Subject: Vac Shoe Bracket Pin Weld Fracture

Models Affected:

- Adphibian (all models)
- AquaPLUS (all models)
- AX651 (all models)

Fig 1- Weld joint failure on vac shoe bracket weldment 56317063

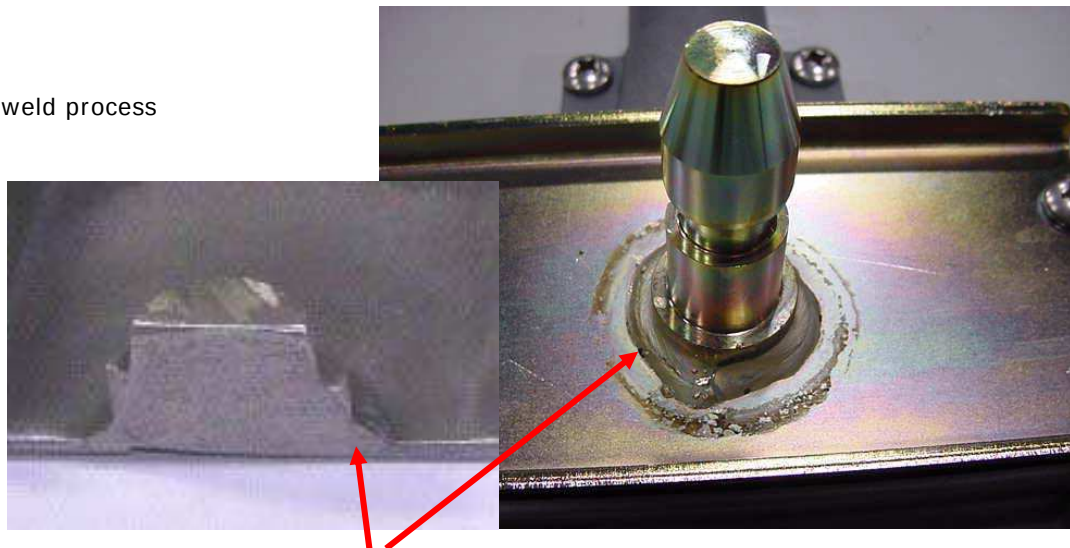
Issue: Pin separates from vac shoe bracket weldment.

Cause: Variation in welding process resulted in undersized weld and poor penetration between shoe bracket and pin.

Shoe bracket weldment with undersized weld and inadequate weld penetration between pin and shoe bracket

Weld w/correct fillet size and penetration.

Fig 3- Vac shoe assembly 56317041

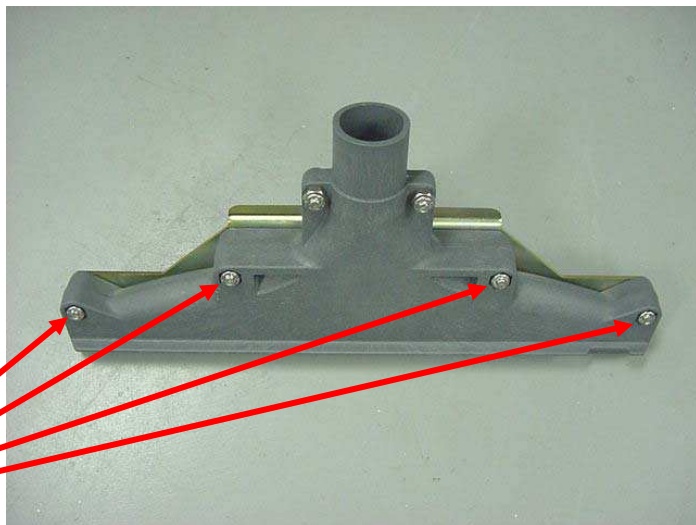
On machines with S/N's prior to those noted below remove shoe bracket weldment 56317063 from shoe ass'y 56317041 & replace as shown in Fig's 3-6.

Remove 4 screws and nuts used to secure vac shoe bracket to shoe housing

Remove vac shoe bracket 56317063.

Fig 6- Install new vac shoe bracket,
reinstall mounting hardware and
torque to 67 in-lbs.

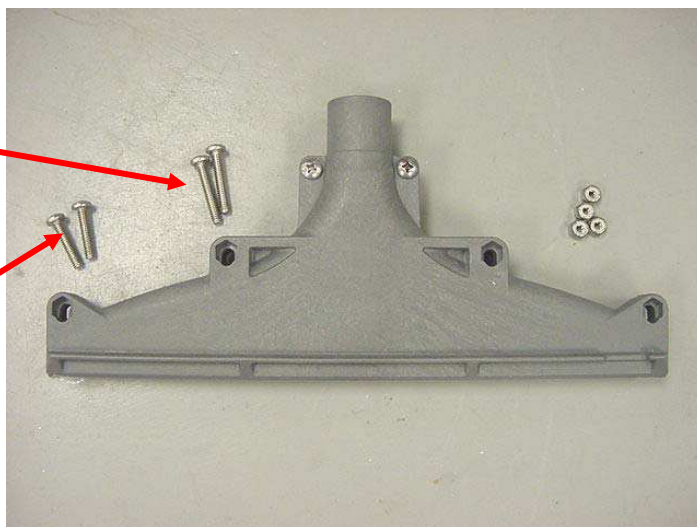
56002905 ¼-20 x 1.5
screws used in inner
positions

56002958 ¼-20 x 1.25
screws used in outer
positions
